Valve Timing Changes – AJ16 Engine

MODEL 1995-96 MY
4.0 NA
VIN 720001-ON

ILLUSTRATION 1

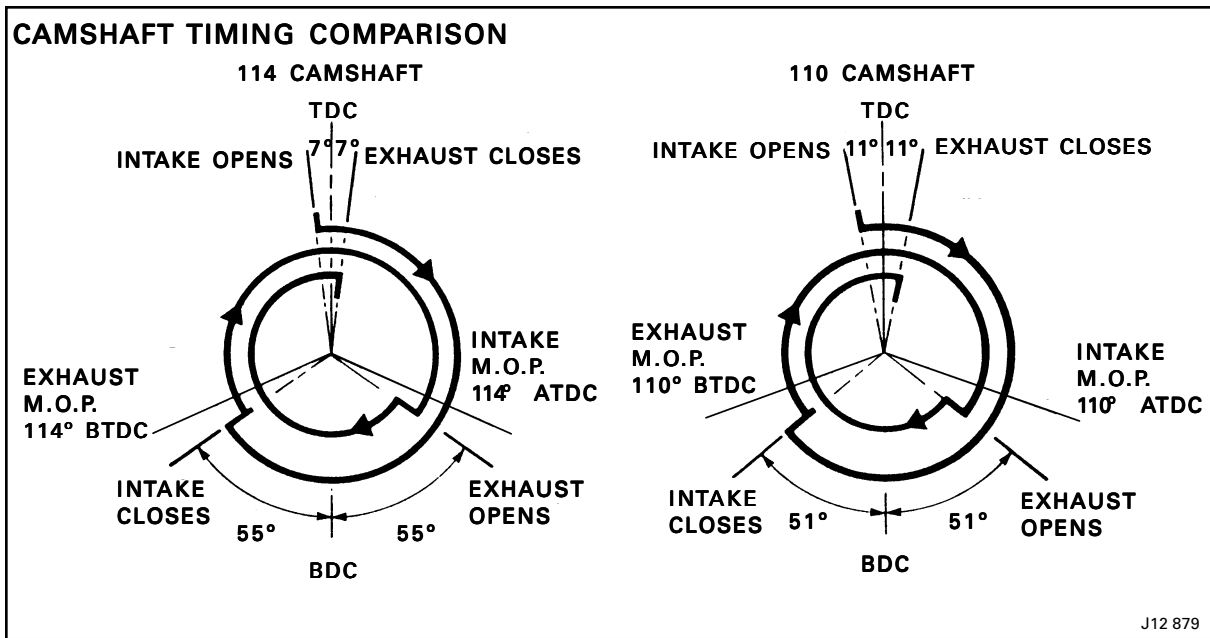
To improve idle quality, revised camshafts with reduced valve timing overlap were introduced on the normally aspirated engines as running change 95/13.

The original camshafts, with a maximum opening position of 110 degrees have been superseded by camshafts with a maximum opening position of 114 degrees. This change is accomplished by machining the camshaft slot in a different

position. The valve timing overlap is reduced from 22 degrees on the 110 camshafts to 14 degrees on the 114 camshafts, Illustration 1.

The maximum opening position of the 114 intake camshaft is 114 degrees after top dead center (ATDC) while the maximum opening position of the exhaust camshaft is 114 degrees before top dead center (BTDC).
